STATE OF NORTH CAROLINA
DEPARTMENT OF TRANSPORTATION

MEMORANDUM TO: Project Engineers
Project Design Engineers

SUBJECT: BRIDGE DRAINAGE SYSTEM

STRUCTURE DRAINAGE SYSTEM DETAILS

FIGURE 12 - 20

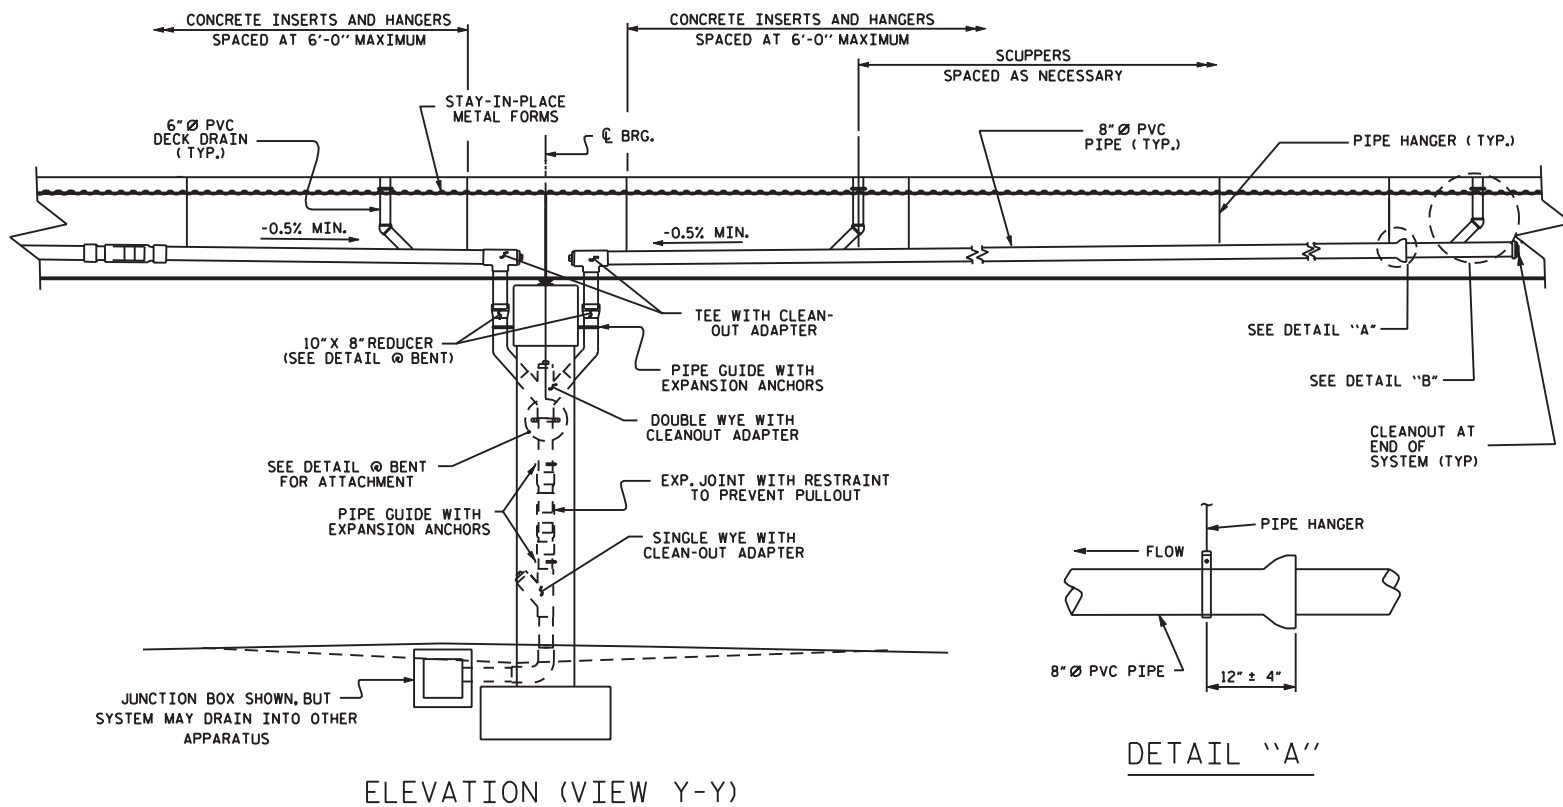
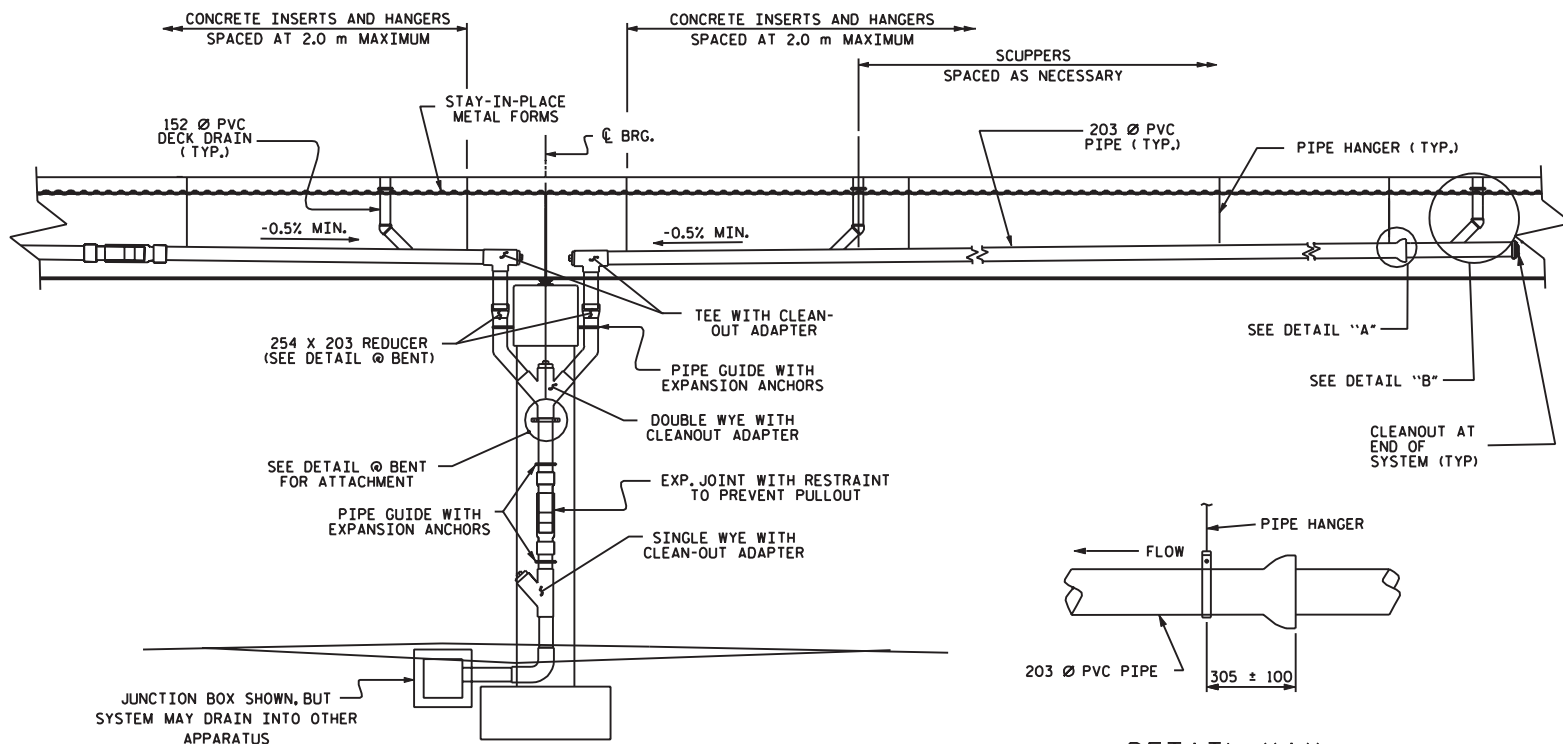
Figure 12-20 has been revised and is attached for your use. The bridge drainage system has been changed so that there is no longer a need to use tee joints. This change has been made due to the high cost of these joints.

In order to increase flow rate and reduce congestion at the connections, the PVC pipe directly below the bridge deck will now have a 45-degree bend as shown in Fig.12-20.

DETAIL "A"

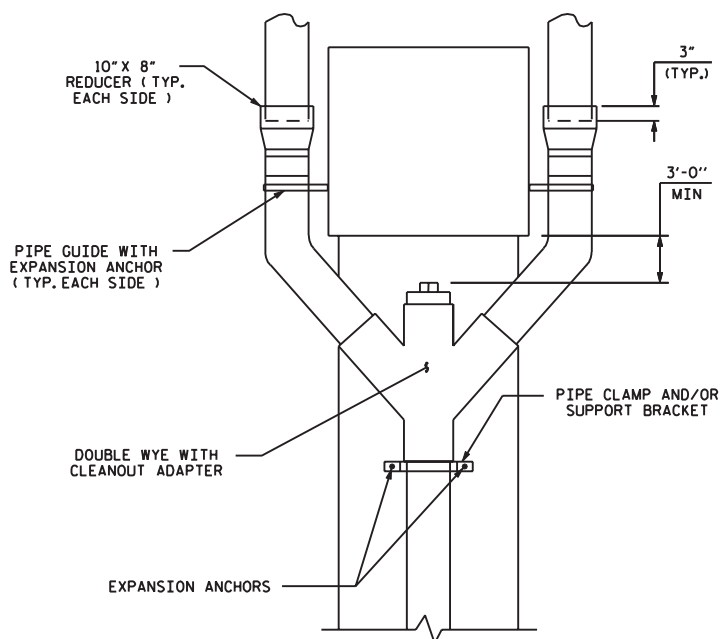
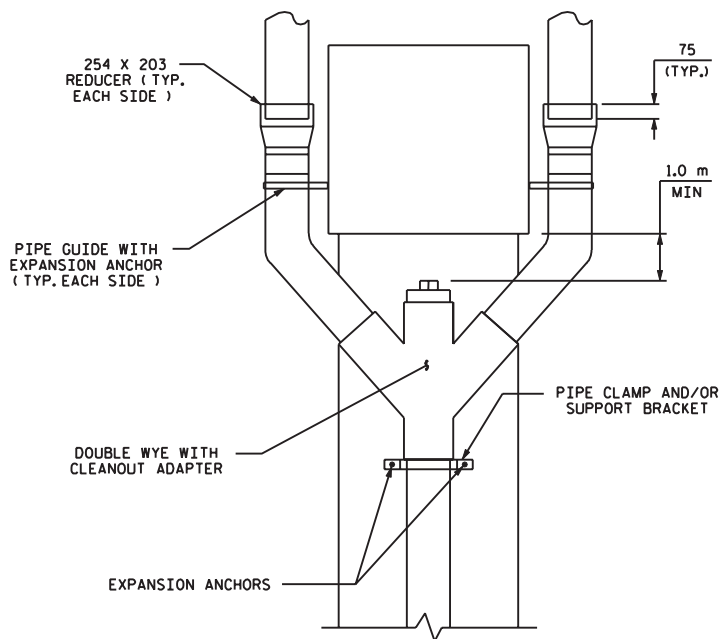
Pipe hangers are to be placed near pipe connections in accordance with "Detail A" to ensure the stability of the drainage system.
